Service Bulletin 011-7210

Relief valves prevent damage to wrist motor slip ring housing

Rate-controlled Slave Arms (RigMaster, Conan 7R, Orion 4R and 7R models) and Hydraulic Pan & Tilt Units

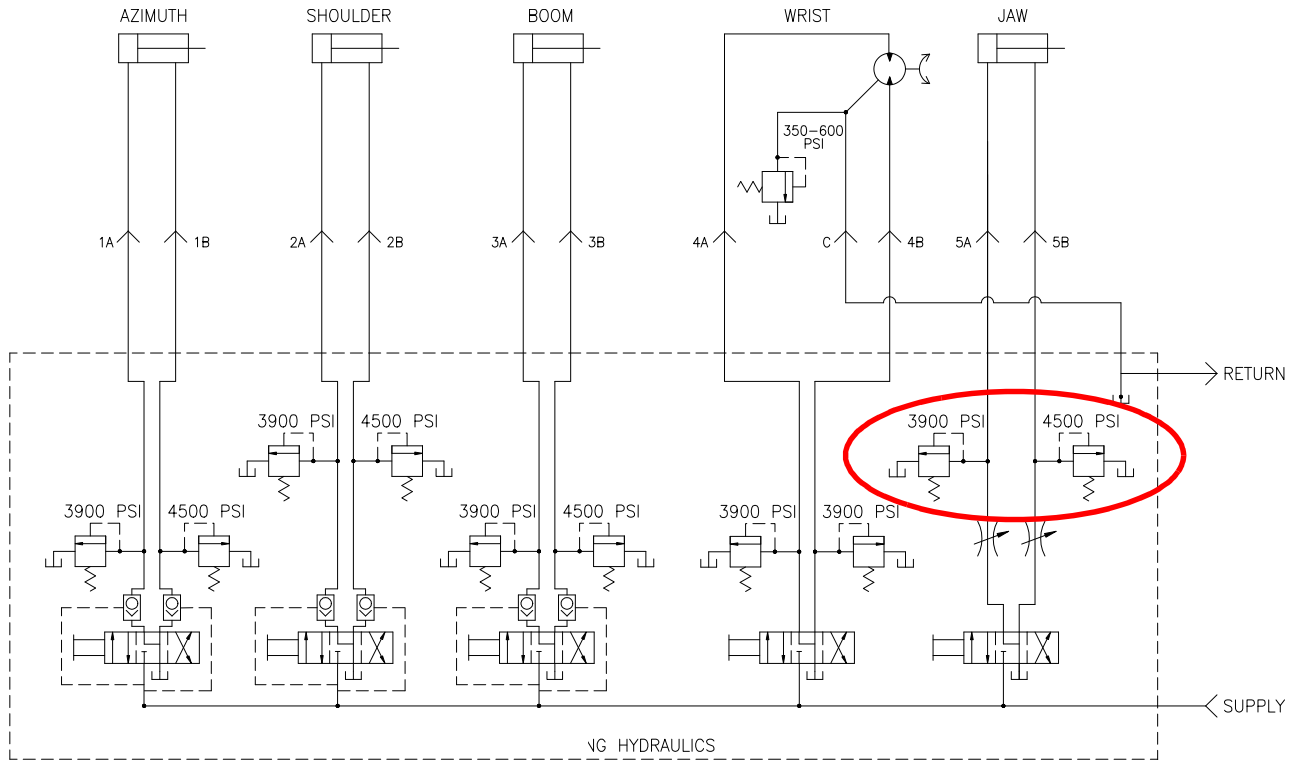
Over pressurization of the Jaw Close 5B circuit/tilt circuit inside the wrist motor may cause the slip ring housing to fracture and allow hydraulic fluid to flow directly into the wrist case drain (hydraulic return). Properly installed over-pressure relief valves will prevent this from occurring.

Without relief valves, housing fractures may occur when the pressure in the cylinder exceeds 5000 psi. This typically occurs when the jaw or tilt assembly is involved in a collision and the piston is forced open. An typical fracture is shown at right (arrow).

Slip-ring housings manufactured after March 10, 2008 have been strengthened in the critical area, but relief valves are still recommended.

Figure 1 Placement and adjustment of over-pressure relief valves

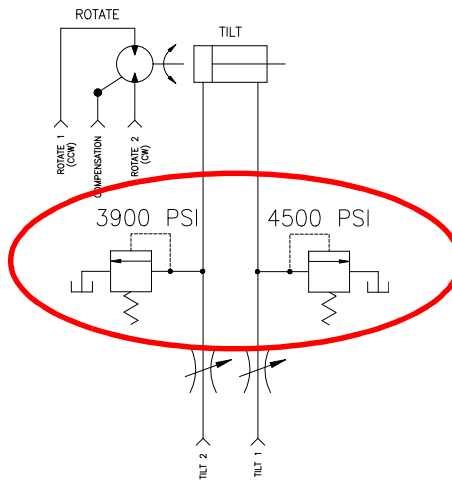
To prevent an over-pressure event, a relief valve must be installed on each hydraulic circuit including the jaw/tilt function (see sample RigMaster and Pan & Tilt schematics on following page). Verify that all rate slave arms and pan & tilt units have properly positioned and adjusted over-pressure relief valves installed for all functions.

If a circuit has an adjustable flow control valve (throttle valve), as shown in the RigMaster jaw and Pan & Tilt tilt schematics, the relief valve must be located between the actuator and the flow control valve.
